ADDENDUM NO. 3, APRIL 30, 2009

RE: Ocean Avenue Elementary School
Portland, Maine
A/E Comm. No. 3316.10

City of Portland RFP No. 7109
BGS project No. 723

FROM: WBRC Architects-Engineers
141 Preble Street
Portland, Maine 04101
Tel: (207) 828-4511

CHECKED BY: MEJ ADD3-AE102-C-1

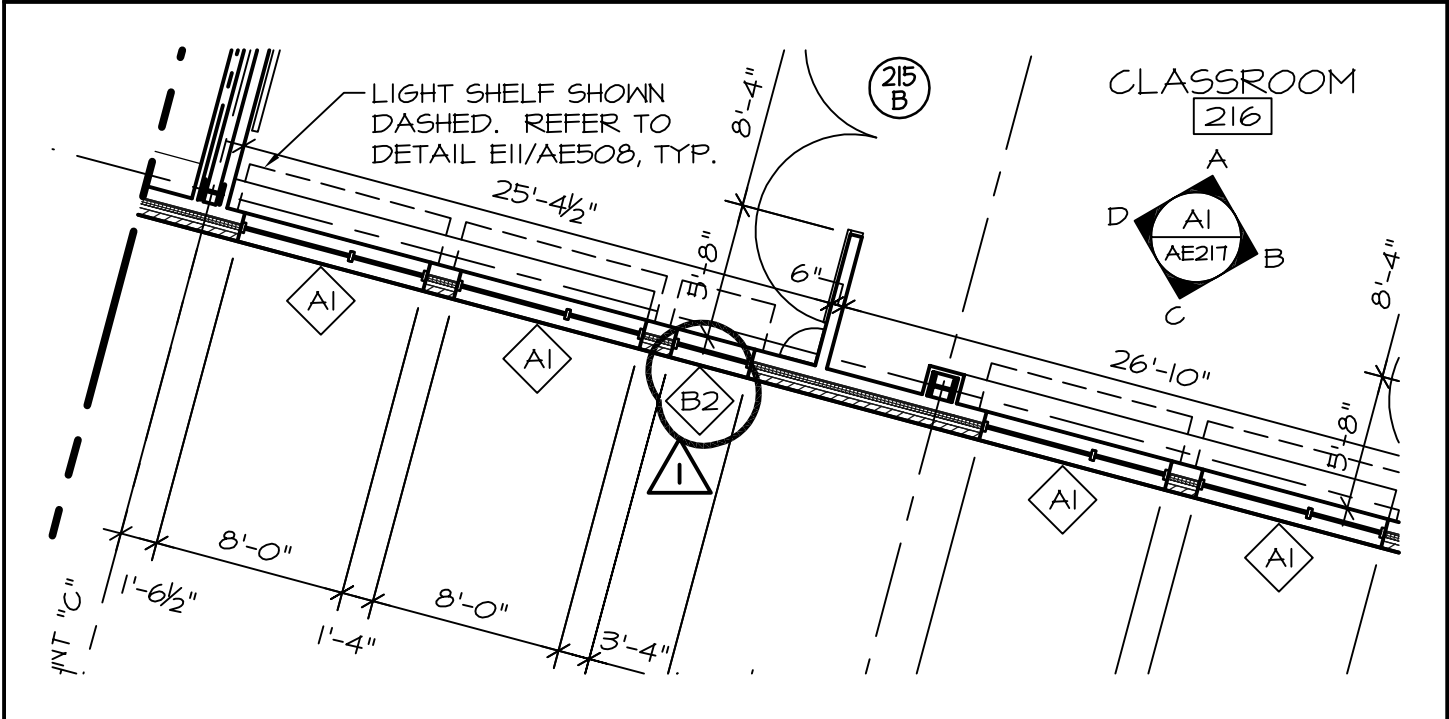
- 24. Sheet AE101-A, First Floor Plan Seg. A, Music #114, ADD Light Shelves at all exterior windows in Music 114 as per Detail E11-AE508.
- 25. Sheet AE102-C, Second Floor Plan Seg. C, REVISE portions as indicated on Sketch ADD3-AE102-C-1.

**ADDENDUM #3
ADDED WINDOW TAGS**

NOTE CHANGE SIMILAR ON SHEETS
 2 AE103-A, AE103-B, AE103-C,
 AE104-A, AE104-B, AE104-C

SCALE:	1/8" = 1'-0"
WBRC CAD FILE:	331610
PROJECT No.	331610
JOB CAP/DRAW:	TRJ
PM: MEJ	SHEET No.
CHECKED BY: MEJ	ADD3-AE103-B-1
DATE: 04-30-2009	© COPYRIGHT 2007 WBRC

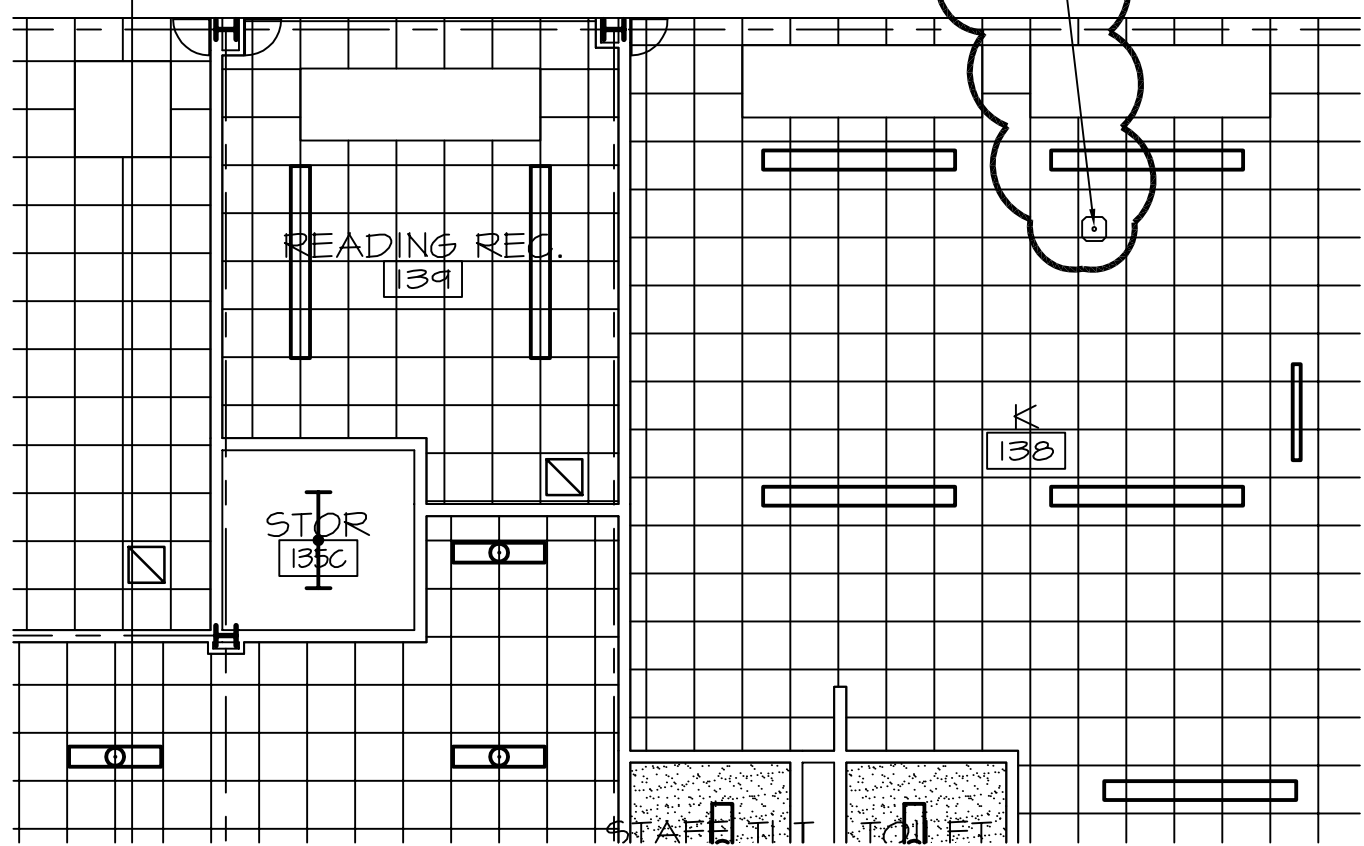
26. Sheet AE103-B, First Floor Reflected Ceiling Plan Seg. B, REVISE portions as indicated on Sketch ADD3-AE103-B-1.
27. Sheet AE201, Exterior Elevations, REVISE portions as indicated on Sketch ADD3-AE201-1.

PROJECTOR CEILING MOUNT BRACKET (05/C1).
 CONTRACTOR TO PROVIDE 1 1/2" PAINTED STEEL
 PIPE DROP WITH THREADED CONNECTION.
 ANCHOR PIPE TO 4X4X3/8 ANGLE STRUT
 SPANNING BETWEEN ADJACENT BEAMS/JOISTS
 AS REQUIRED TO SUPPORT PIPE (SUPPLIED
 UNDER SECTION 05 50 00). PROVIDE
 ESCUTCHEON RING WHERE PIPE PASSES THROUGH
 APC, TYPICAL. CONFIRM FINAL LOCATION OF
 DROP AND PIPE SIZE WITH OWNER

PM: MEJ SHEET No. ADD3-AE304-1

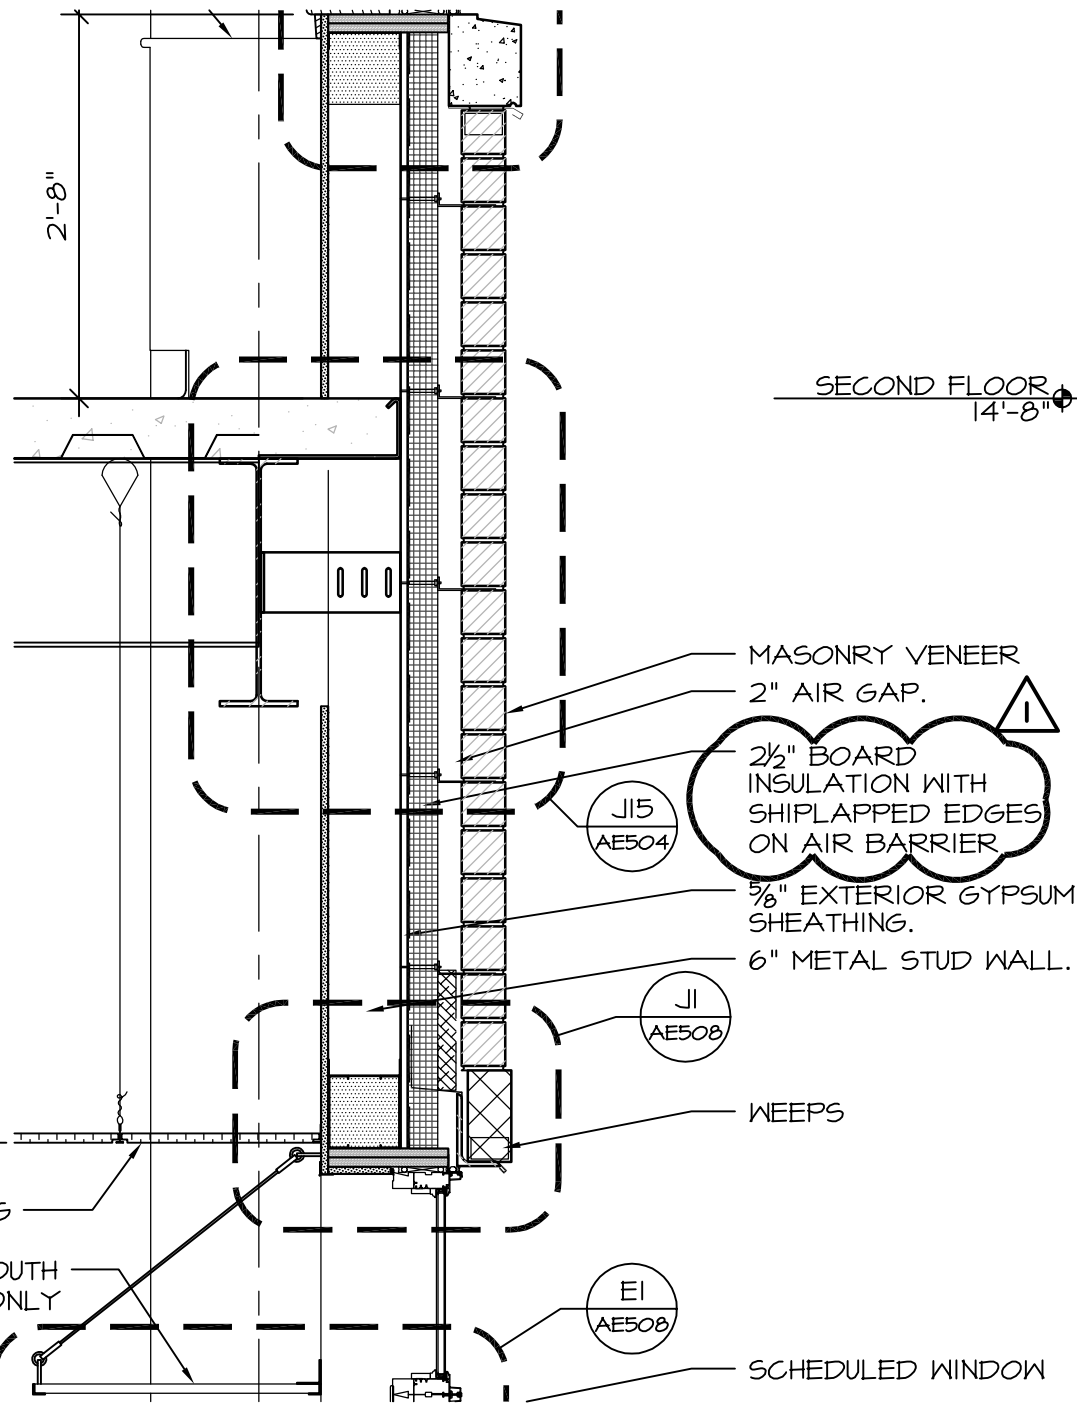
28. Sheet AE202, Exterior Elevations, Key Plan, CHANGE elevation reference “N7” to “N6”.
29. Sheet AE304, Wall Sections, REVISE portions as indicated on Sketch ADD3-AE304-1.

NOTE REVISION

SCALE:	AS NOTED
WBRC CAD FILE:	AE306
PROJECT No.	3316.10
JOB CAP/DRAW:	JLS
PM: MEJ	SHEET No.
CHECKED BY: MEJ	ADD3-AE306-1
DATE: 04-30-09	© COPYRIGHT 2009 WBRC

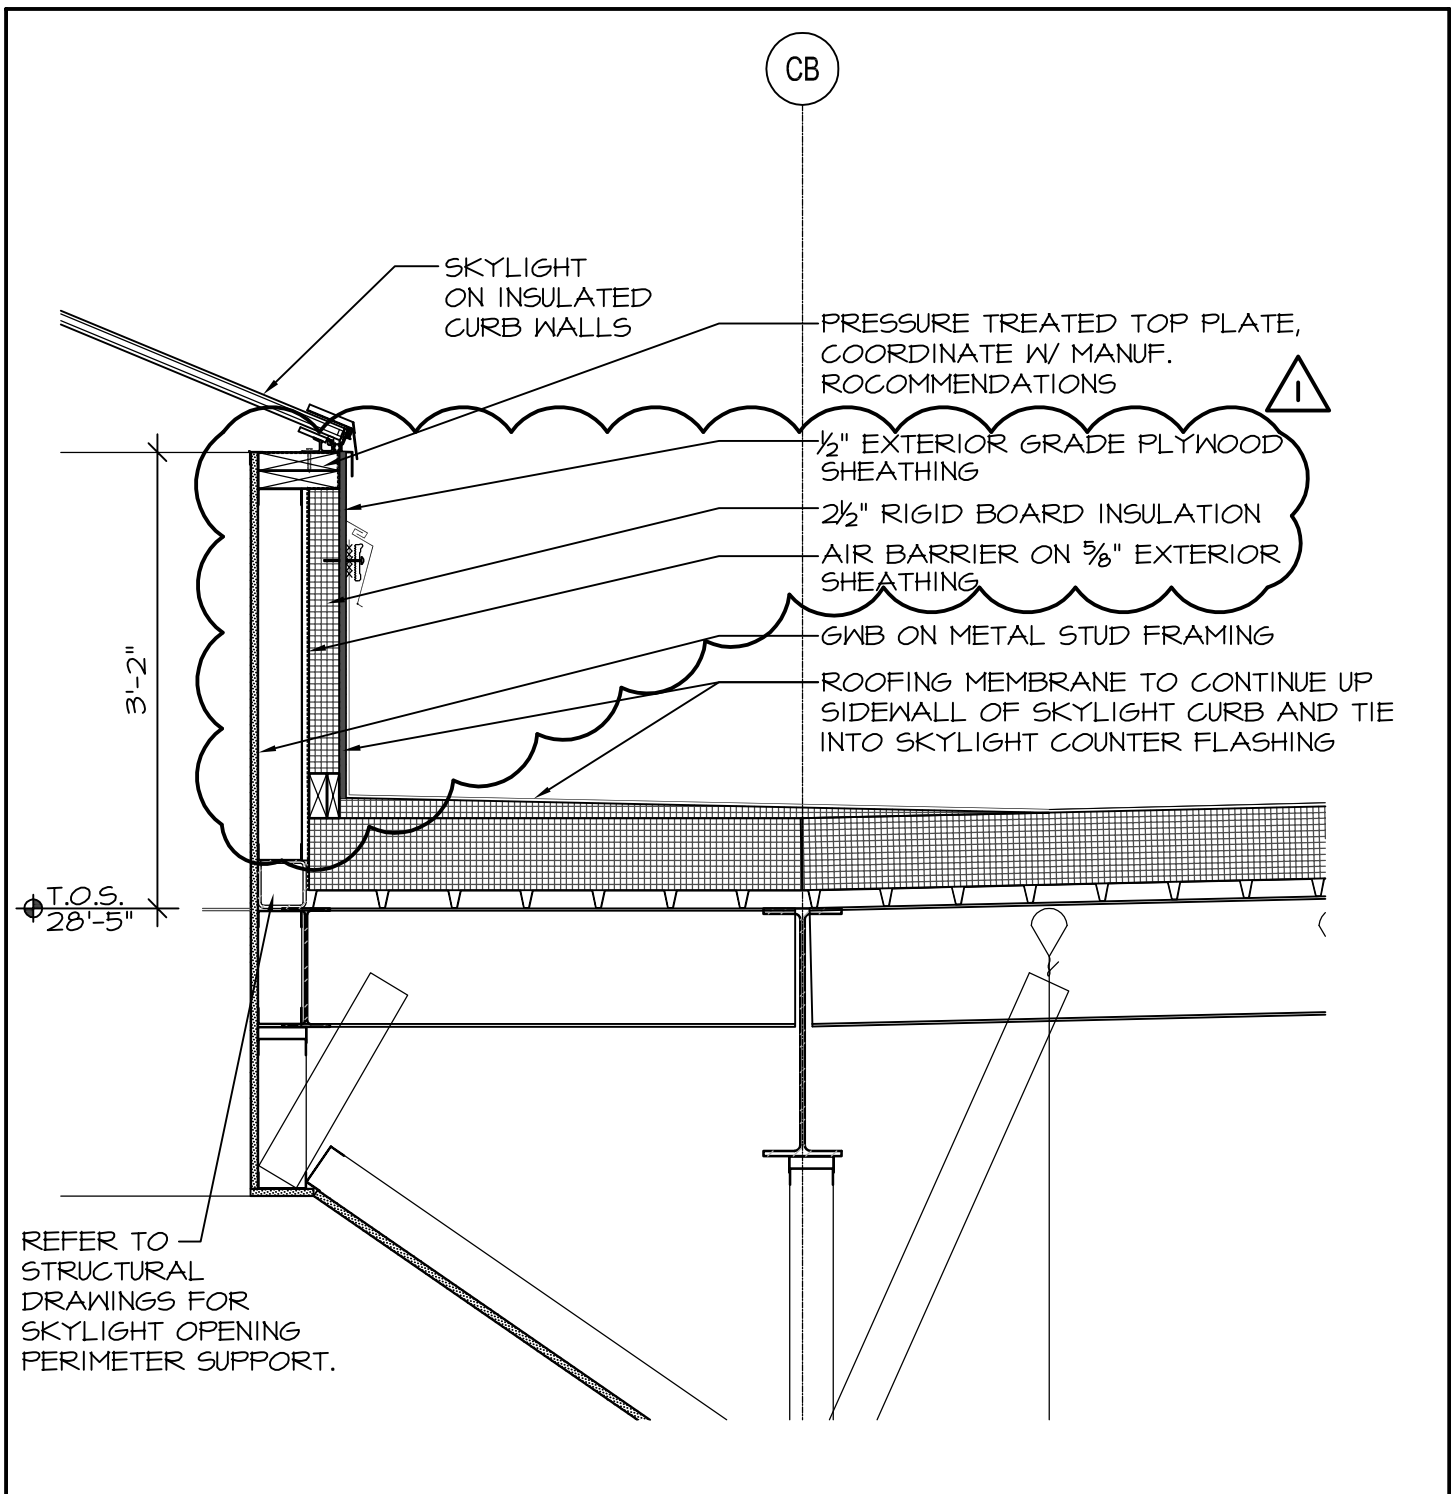
30. Sheet AE306, Wall Sections, REVISE portions as indicated on Sketch ADD3-AE306-1.
31. Sheet AE504, Wall Details, REVISE portions as indicated on Sketches ADD3-AE504-1 and ADD3-AE504-2.

CURB DETAIL REVISION
ADDENDUM 3

SCALE:	3" = 1'-0"
WBRC CAD FILE:	331610
PROJECT No.	331610
JOB CAP/DRAW:	TRJ
PM:	MEJ
CHECKED BY:	MEJ
DATE:	04-30-2009
SHEET No.	ADD3-AE508-1

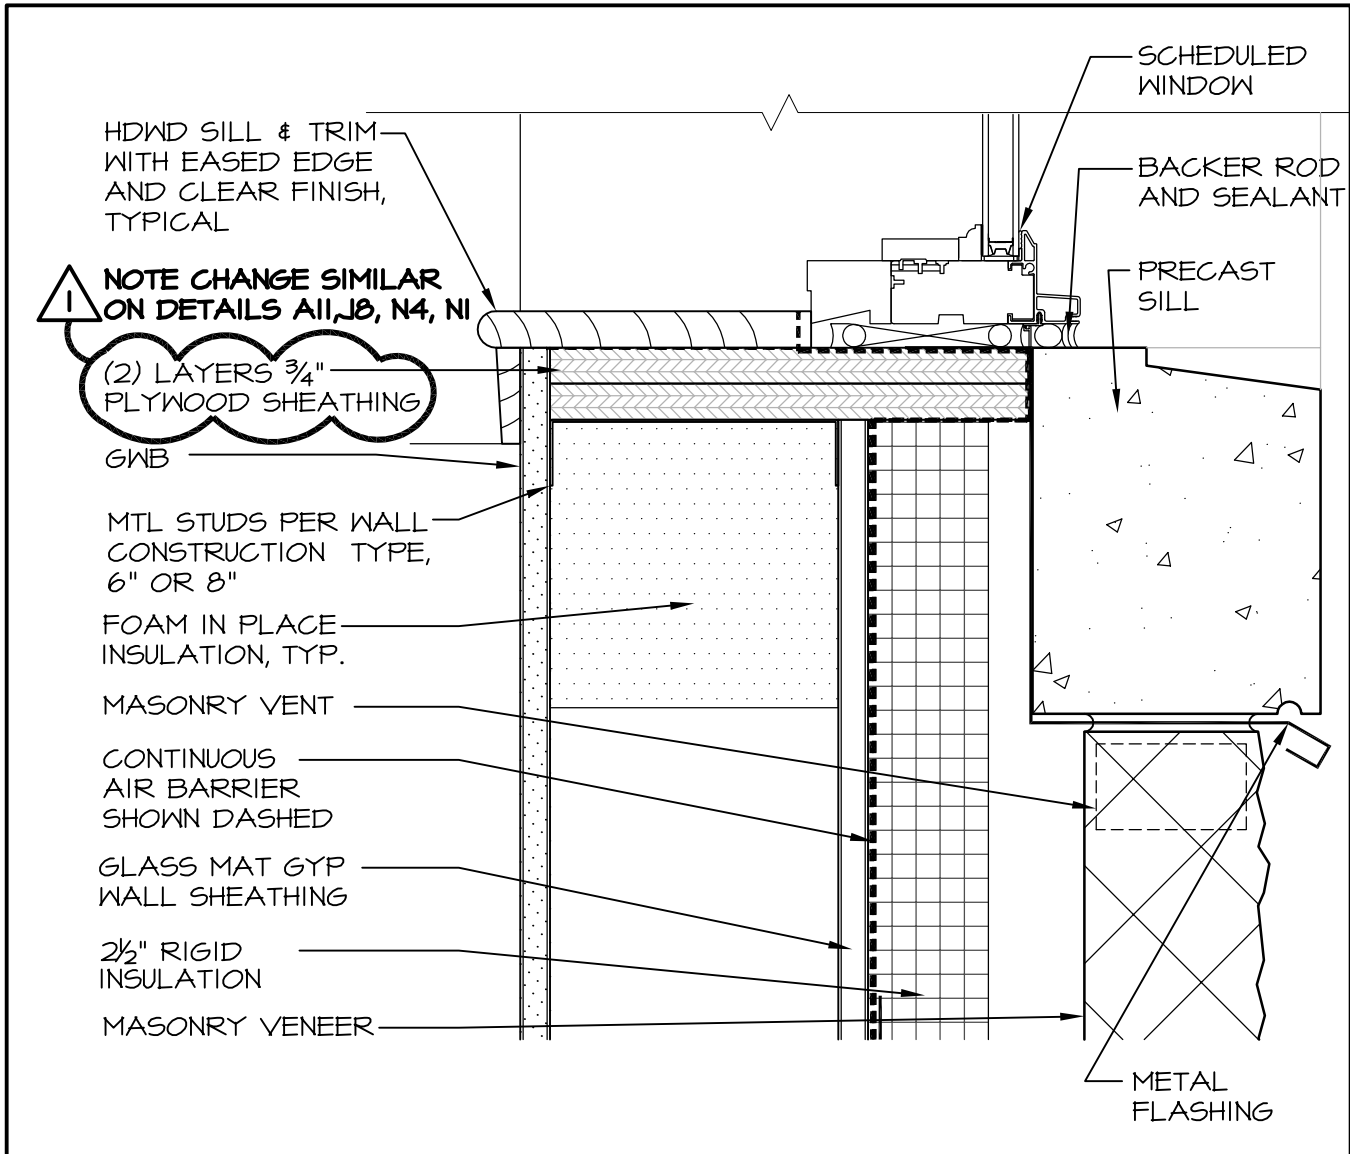
32. Sheet AE508, Window Details, REVISE portions as indicated on Sketch ADD3-AE508-1.
33. Sheet PL601, Plumbing Legend & Schedules, REVISE portions as indicated on Sketch ADD3-PL601-1.

**ADDENDUM #3
REVISED NOTE**

ADD3-ES101-1

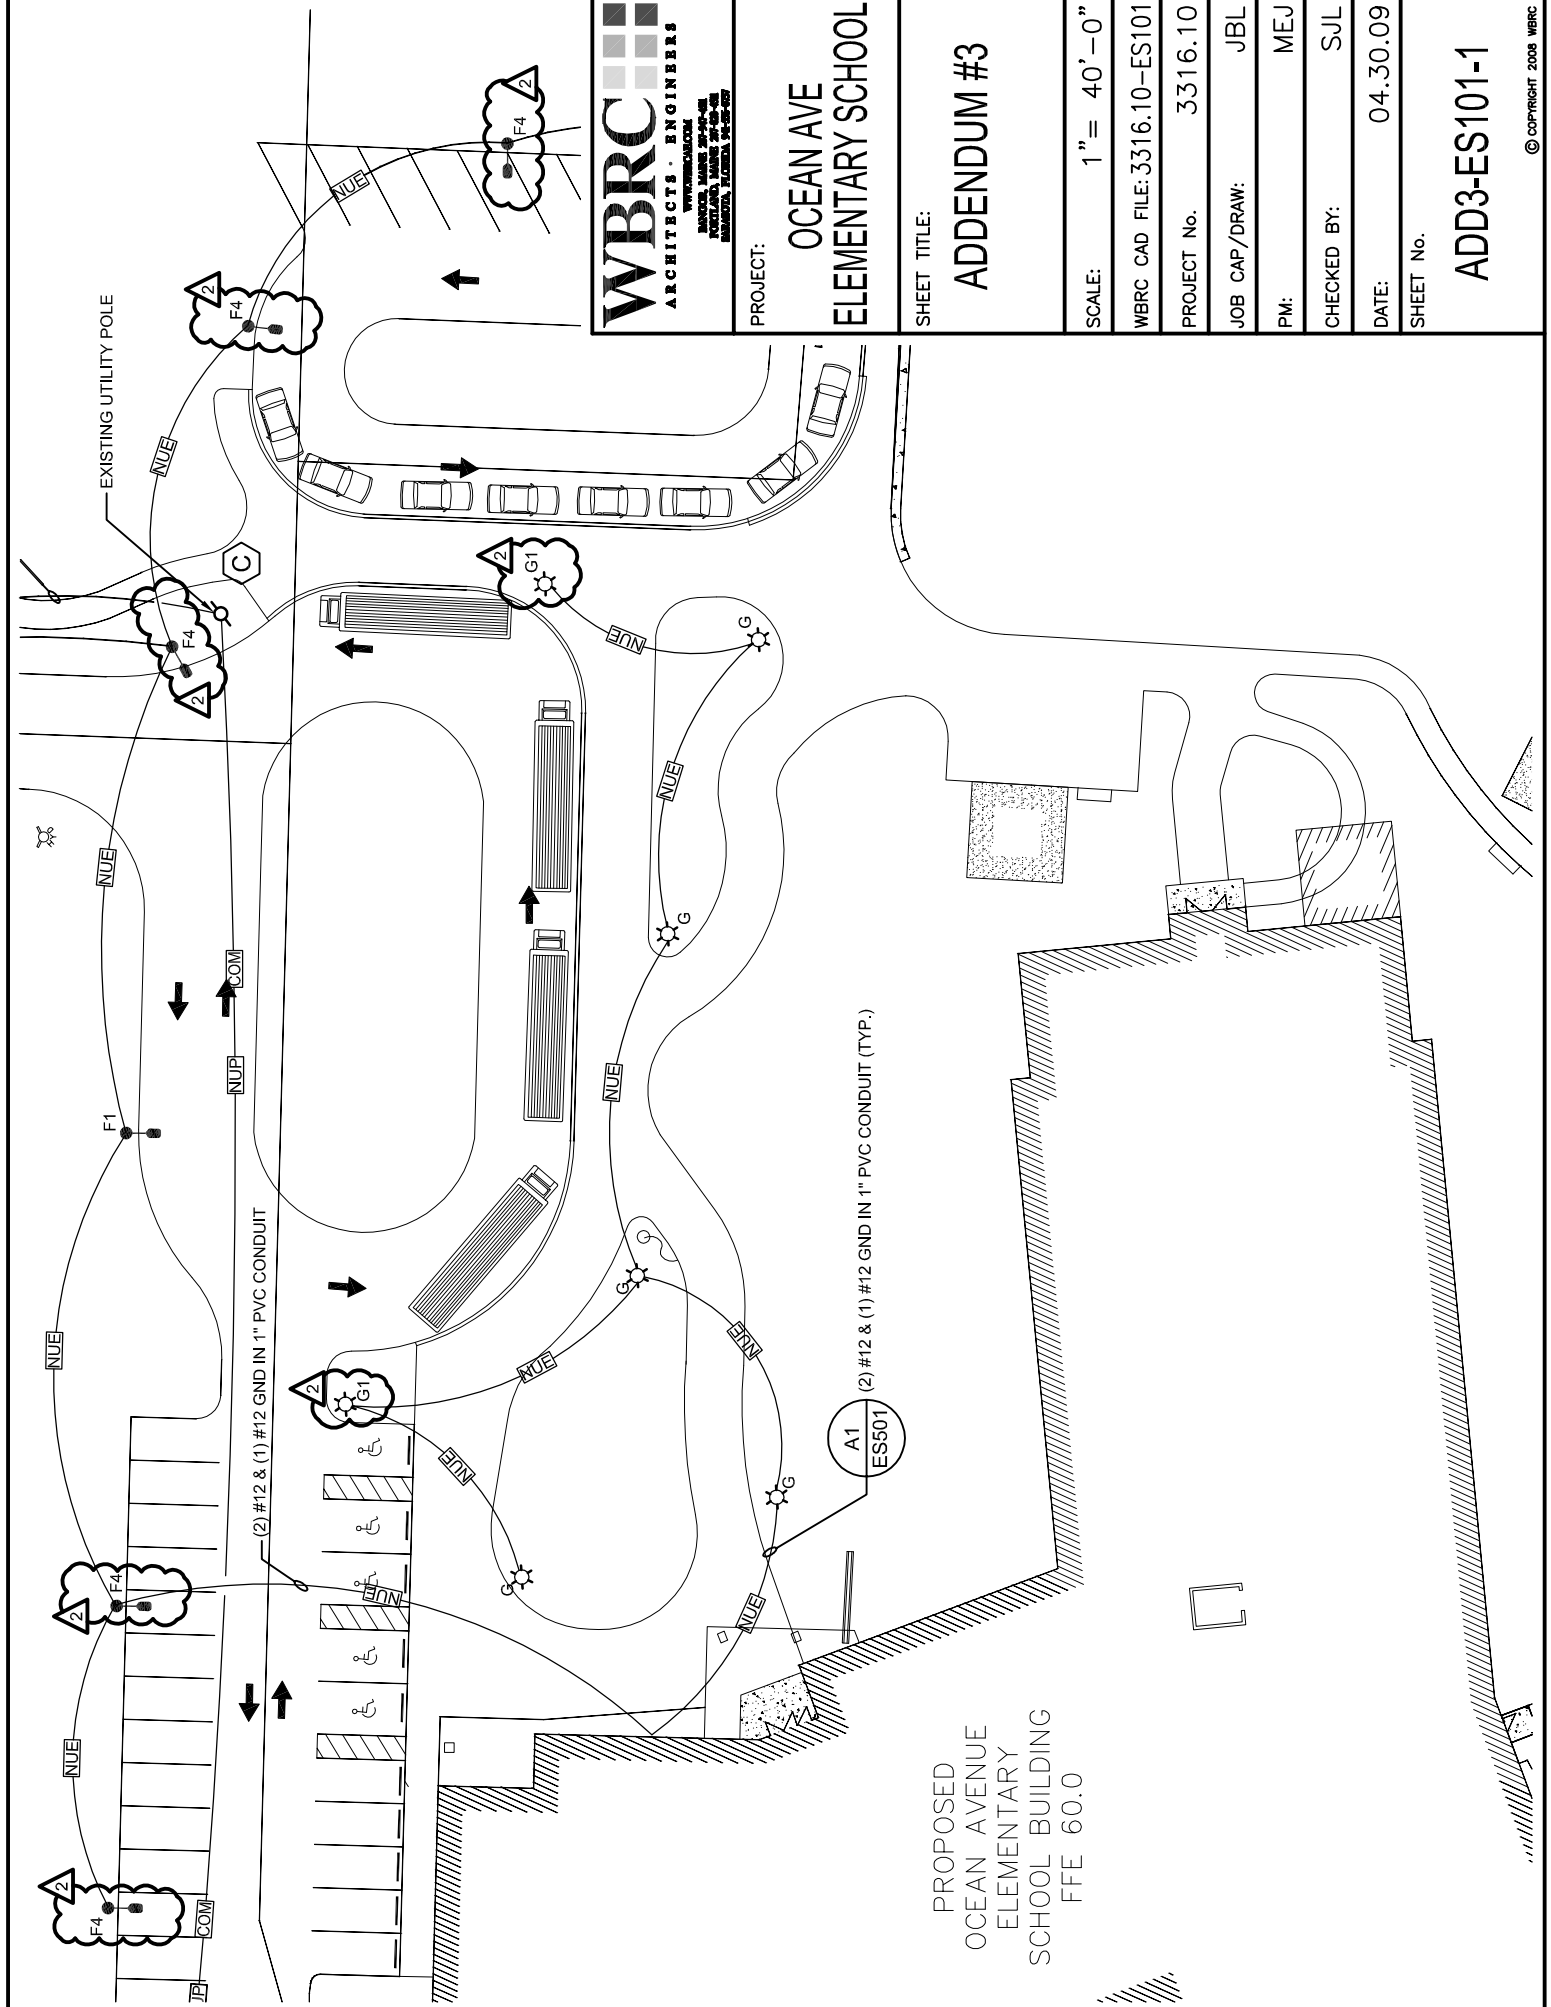
34. Sheet E-001, Electrical Legend & Light Fixture Schedule, REVISE portions as indicated on Sketch ADD3-E-001-1.
35. Sheet ES101, Site Electrical Plan, REVISE portions as indicated on Sketch ADD3-ES101-1.
